Permit Application Review

Permit No. 2019-01
Received complete: March 14, 2019

Applicant: Kristina Smitten; Pentagon North, LLC.
Consultant: Pat Sveum; Pierce Pini and Associates
Project: Exterior Improvements – Pentagon Park North
Location: 4510-4660 West 77th Street: Edina
Rule(s): 3,4,5,11 and 12
Reviewer: BCO

Potential Wetland Buffers
 Pentagon Park, Edina

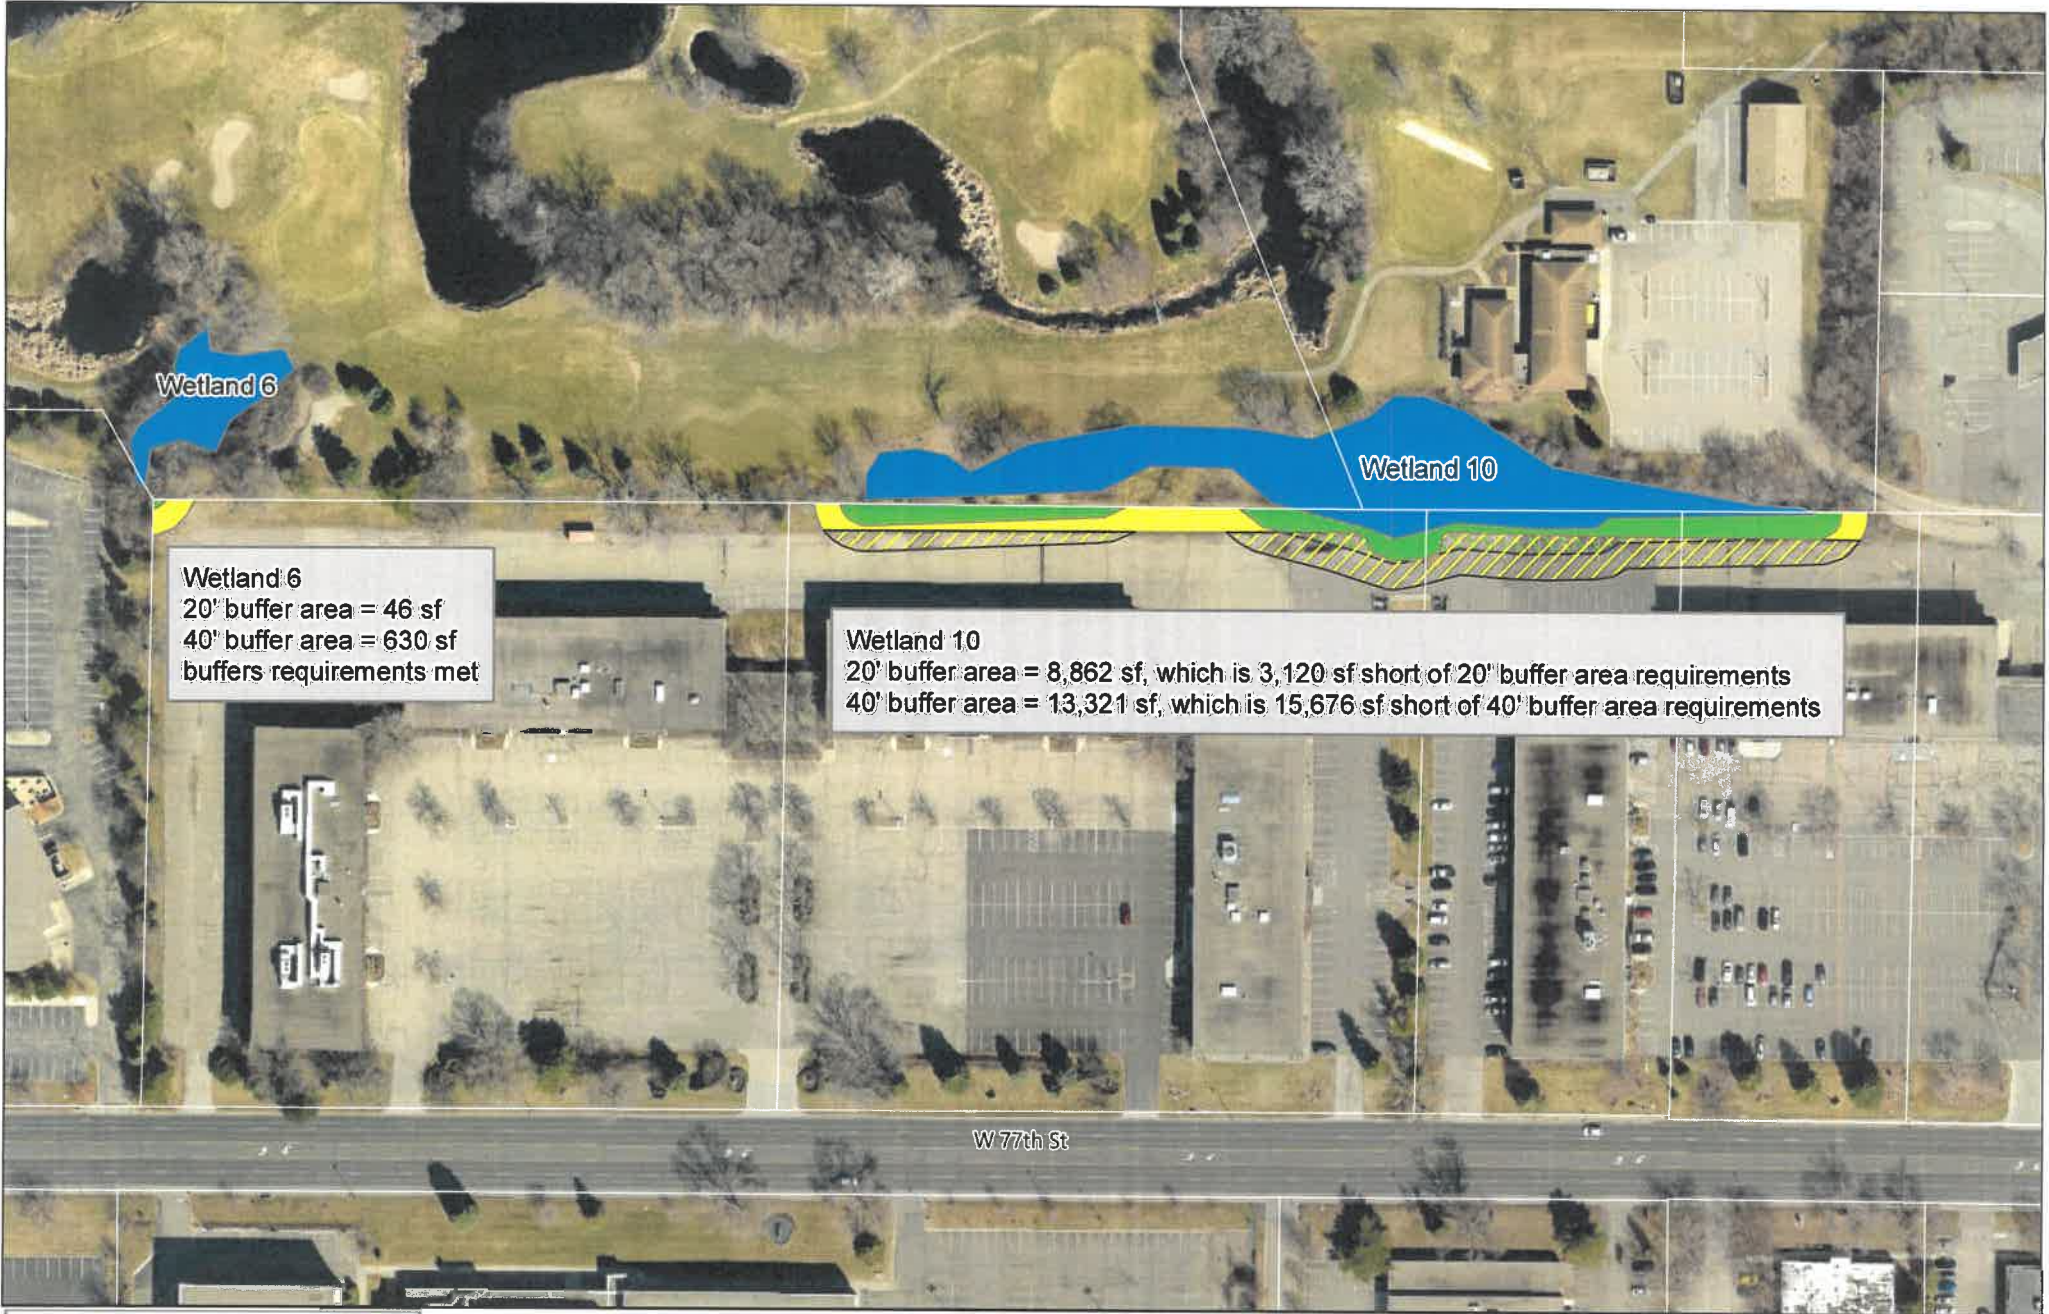
There are two wetlands, #6 and #10 as shown on the attached figure, that have been identified as medium value wetlands that are located along the northern limits of the Pentagon property, primarily within City property. The requirements of the District's buffer rule, 3.4, requires a minimum 20 foot and 40 foot average buffer to be provided for a medium value wetland. The wetland boundary of Wetland 10 extends onto Pentagon North property and is within approximately 5 feet of the back-of-curb of the northern parking lot. The portion of the 40 foot average buffer required on the Pentagon North property would be 29,000 square feet. Because of the limits of the existing parking lot, a buffer area of 13,300 square feet is to be provided, a shortfall of 15,700 square feet requiring a variance. The 20 and 40 foot buffer required for Wetland #6 is provided. For both wetlands, the adjacent areas of the property where buffer is required will not be disturbed by the proposed work and the area between the wetland and the limits of the existing parking lot is currently in a natural condition and heavily vegetated. The maintenance declaration for the permit will require that the buffer area be managed in a naturalized condition to encourage growth of native vegetation and eliminate invasive species.

A variance request for compliance with Rule 3.4.1b (attached) has been prepared by Pierce Pini and Associates on behalf of the applicant to address Rules 10.1-10.4. The variance request is for compliance with the required wetland buffer requirements from the wetland boundary of the riparian Wetland #10. The location of the existing parking lot does not allow for compliance with the 20 foot minimum or the 40 foot average buffer requirement. This existing condition will not change as a result of the project. The alternative to not approving the variance would be to request the applicant remove a portion of the existing parking lot for compliance with the District's buffer requirements. This has not been done in the past nor is the engineer recommending this be required of the applicant.
